B-D BECTON-DICKINSON

June 3, 1985

Reference: Docket No.: 030-06891
License No.: 06-13514-01
Control No.: 03572

Please find attached the additional information requested for our license renewal.

OPERATING PARAMETERS AND SPECS

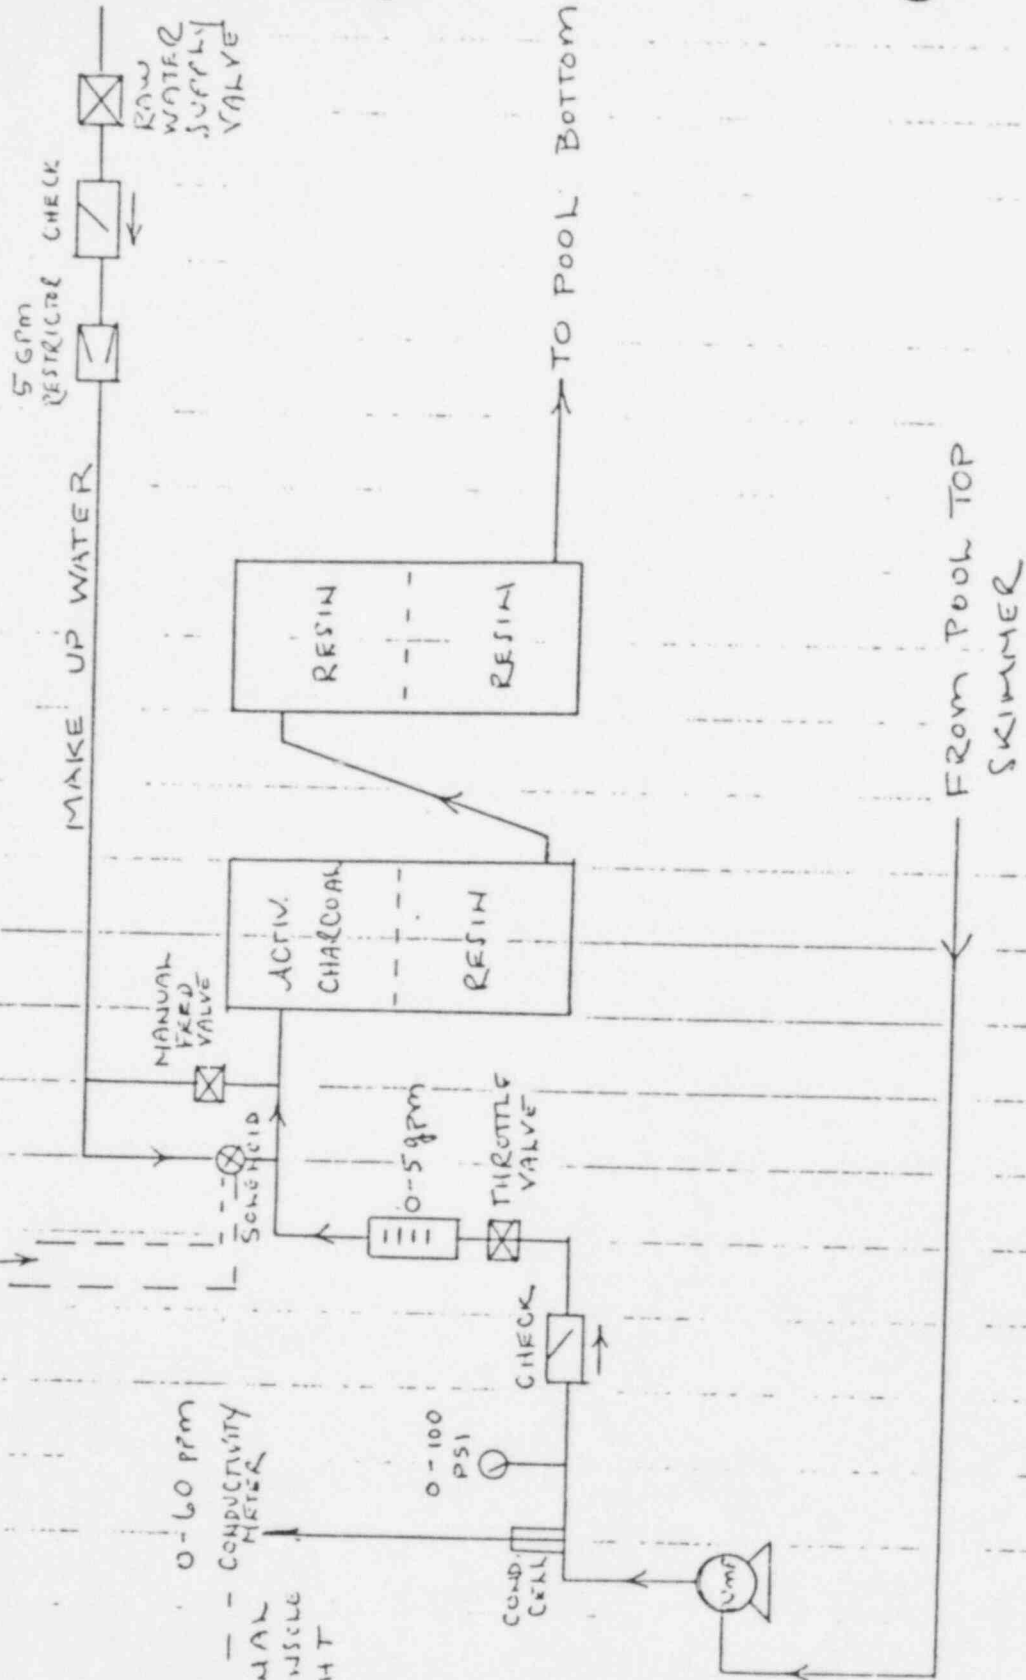
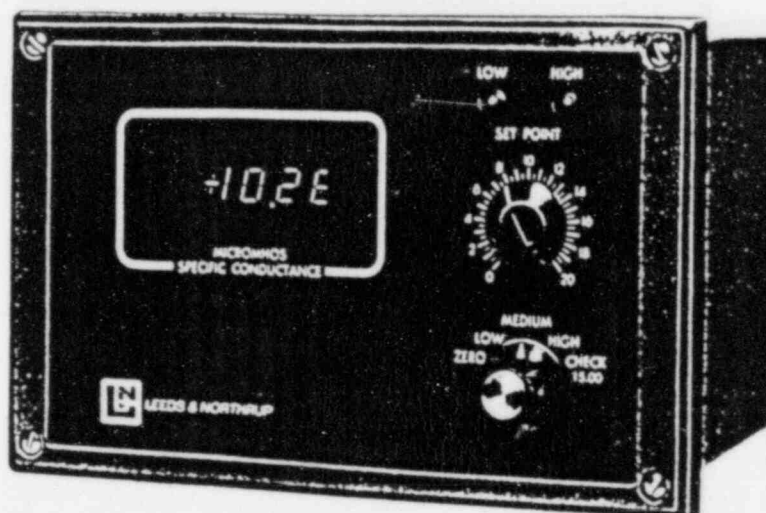
- 1) Flow manually set at throttle value.
- 2) Solenoid valve in make up water line operated by signal from float switch in pool. Pump shuts off during this sequence.
- 3) Conductivity meter preset for proper concentrations. Light on console lights when conductivity rises above set level. Meter may be read manually also.
